Access Compliance Report

Public Rights-of-Way

Intersection ID: 48088	Main Street: MALLARD_HIGHLANDS_DR	Cross Street: JOHN_ADAMS_RD	Location:	S
ADA ID: 229B5D191691	Ramp Type: BlendTrans1	Initial Pass/Fail: Fail	Overall Compliance: No	Severity Score: 10

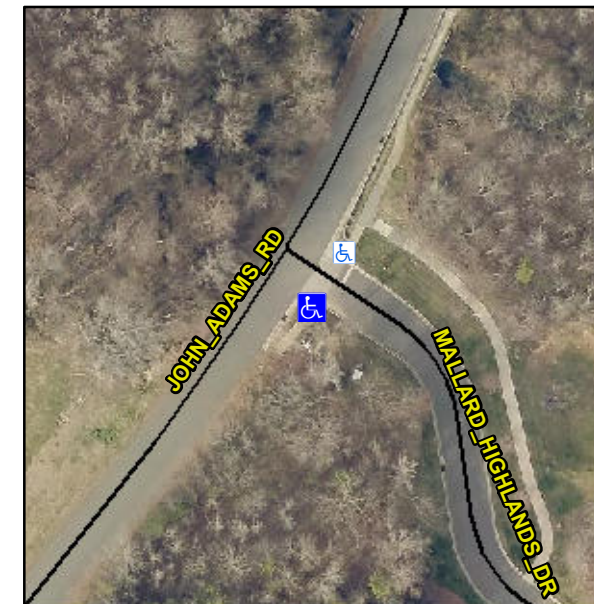
R304.5.1, R304.5.3

Compliance	Description	Data	Compliance	Description	Data
N/A	Ramp Length (in)	58.0	Yes	BlendTrans Slope (%)	0.1
No	Ramp Width (in)	47.0	No	BlendTrans XSlope (%)	4.1
N/A	Flare Type LT	N/A	N/A	Flare Type RT	N/A
N/A	Flare Slope LT (%)	N/A	N/A	Flare Slope RT (%)	N/A
N/A	Flare Traversable LT?	N/A	N/A	Flare Traversable RT?	N/A
N/A	Landing Length (in)	N/A	N/A	DWS Provided?	N/A
N/A	Landing Width (in)	N/A	N/A	DWS Contrast?	N/A
N/A	Landing Slope (%)	N/A	N/A	DWS Length (in)	N/A
N/A	Landing X Slope (%)	N/A	N/A	DWS Full Width?	N/A
N/A	Landing Curb? (Y/N)	N/A	N/A	DWS Offset (in)	N/A
N/A	Shared Landing?	N/A			
N/A	Gutter Ponding?	N/A	N/A	Gutter Slope (%)	N/A
N/A	Gutter Lip Ht (in)	N/A	N/A	Gutter X Slope (%)	N/A
N/A	Painted X Walk1?	No	N/A	Painted X Walk2?	N/A
	X Walk 1 Direction	To NE		X Walk 2 Direction	N/A
	X Walk 1 Width (in)	N/A		X Walk 2 Width (in)	N/A
	X Walk 1 Slope (%)	0.7		X Walk 2 Slope (%)	N/A
	X Walk 1 X Slope (%)	1.9		X Walk 2 X Slope (%)	N/A

Remove & Replace Curb Ramp With Two New Directional Ramps or Equivalent.
